# ALTERATION TO A HISTORIC PROPERTY STAFF REPORT

Site: 117 Washington Street c.1789-1792 Samuel Ireland House Case: HPC 2015.045 Single Building Local Historic District

Legal Notice: Replace 3-tab asphalt with architectural shingle roof

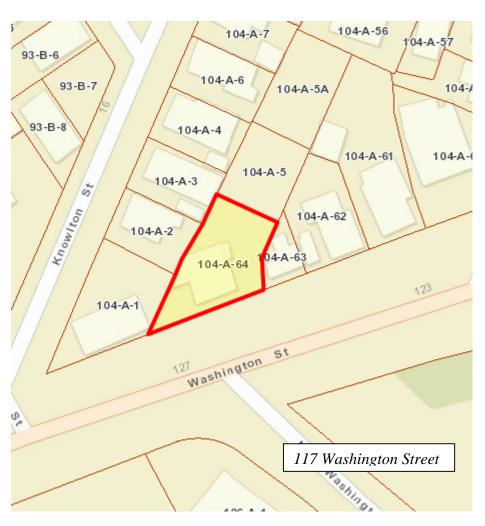
The original roof had wood shingles as can be seen in the photo below.

The proposed Timberline® shingles do not replicate historic wood shingles. The exposure and size of the existing 3-tab asphalt shingles is closer to the original wood shingle and closer to the Slateline® architectural shingle than the proposed Timberline® shingles.

Visible flashing should be restricted to chimneys. It should not be visible on the roof of in an 18<sup>th</sup> century house.

- 3. The roofing material shall be Slateline® in English Gray, Antique or Weathered Slate color.
- 4. Flashing shall be copper or terne metal.
- 5. No flashing or drip edges shall protrude more than ½" along the eaves.
